SUNDRY NOTICES AND REPORTS ON WELLS
Do not use this form for proposals to drill or to re-enter an abandoned well. Use form 3160-3 (APD) for such proposals.

Kinder Morgan CO2 Company, LP (KM) proposes to amend the storm water controls for the CB-4 well location per the attached narrative, diagram and landowner approved seed mix, and plans to initiate construction on approximately 9/26/2019.

Storm Water/Reclamation

CB-4 Well Pad Storm Water Diagram

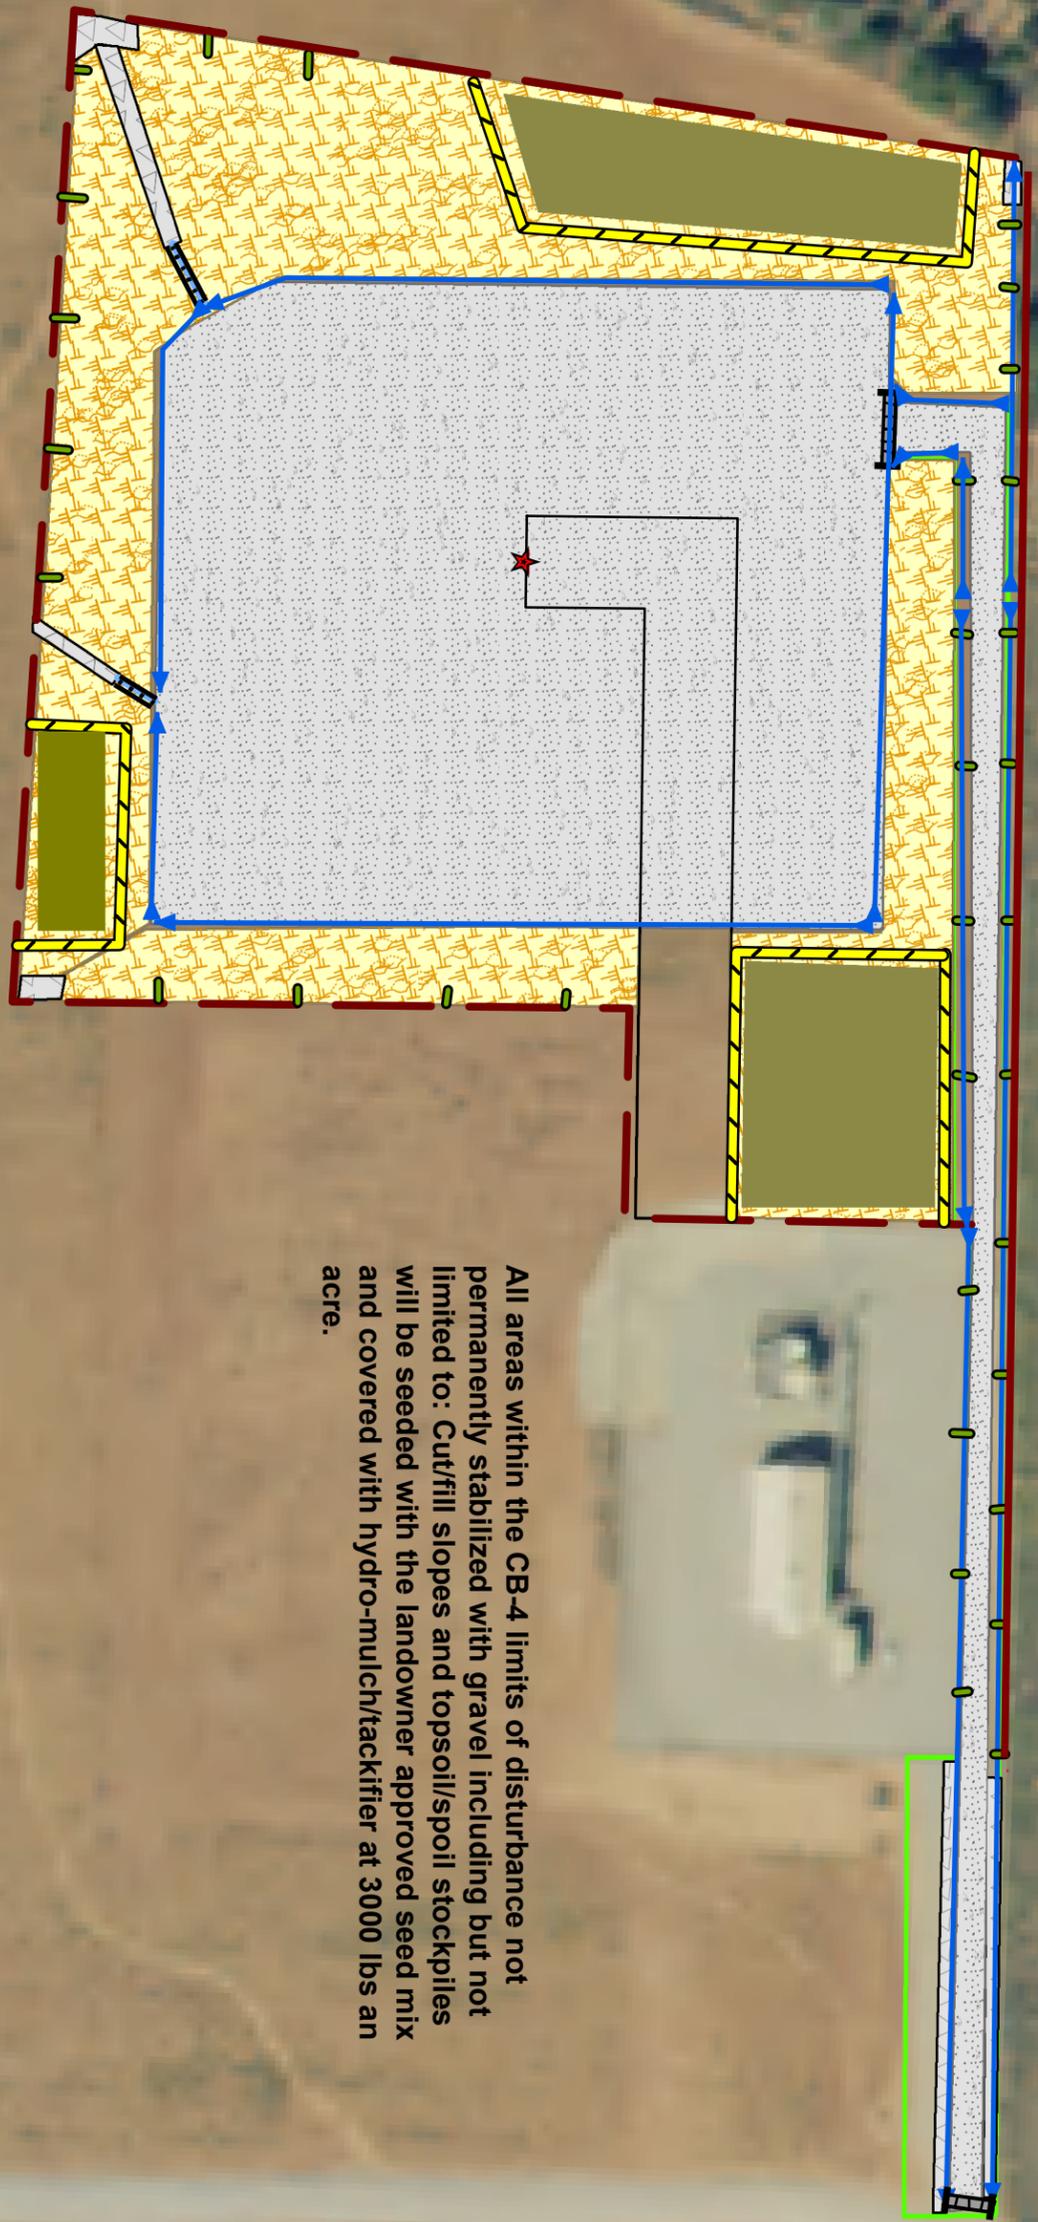
Storm water control measures shall be installed in accordance with the attached storm water control measures map, this narrative, the attached storm water control measure installation details, and as discussed during the site visit.

- Install 2600 feet of compacted earthen berm. (First thing to be installed.)
- Install 35 rock velocity checks utilizing 4-6 inch angular rock.
- Install inlet/outlet protections on the culvert at the pad entrance. The inlet/outlet protections will be 6'x3' utilizing 4-6 inch angular rock.

- Install 1050 feet of wattles around the topsoil/spoil piles.
- Apply Terra Matrix hydro mulch at 3000 lbs/acre to all areas of disturbance not covered with gravel. This includes all cut/fill slopes, and areas along access road. There are approximately 4.5 acres that will require Terra Matrix Hydro Mulch.

- Install two (2) slide gates(see attached spec). Each slide gate will require approximately 30 feet of 8 inch PVC pipe.
- Install 1-10'x6' armor outlet

- Install 1-15'x6' armored outlet
- Install 1-120'x6' armored outlet
- Install 1-20'x30' armored outlet
- Install 1-50'x6' armored outlet
- Install 1 240x10 armored rundown along north side of access road near the intersection with Cty RD 8. Rock utilized for this shall be hauled from Cty Rd 12 stock pile yard.

All areas within the CB-4 limits of disturbance not permanently stabilized with gravel including but not limited to: Cut/fill slopes and topsoil/spoil stockpiles will be seeded with the landowner approved seed mix and covered with hydro-mulch/tackifier at 3000 lbs an acre.
